Amendments to the Drawings:

REMARKS/ARGUMENTS

Appl. No. 10/618,187 Amendment dated July 20, 2007 Reply to Office Action of March 22, 2007

ANNOTATED DRAWING

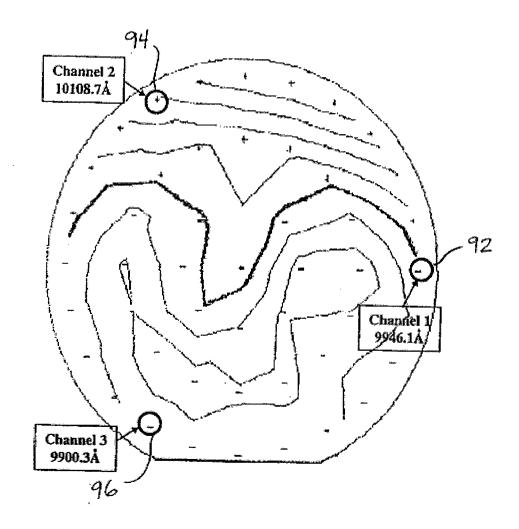
The attached sheet of drawings includes changes to Fig. 7. This sheet, which includes Fig. 7, replaces the original sheet including Fig. 7.

In an office action mailed June 22, 2007 (hereinafter "Office Action"), the Examiner objected to the drawings, including Fig. 7, for failing to comply with 37 CFR 1.84(p)(5) as not including reference signs 90, 92, 94 and 96 that were mentioned within the description. Accordingly, Applicant submits replacement drawings attached with this response to correct these informalities. As these reference signs were included in the application as originally filed on July 10, 2003 (hereinafter "Application"), no new matter has been introduced.
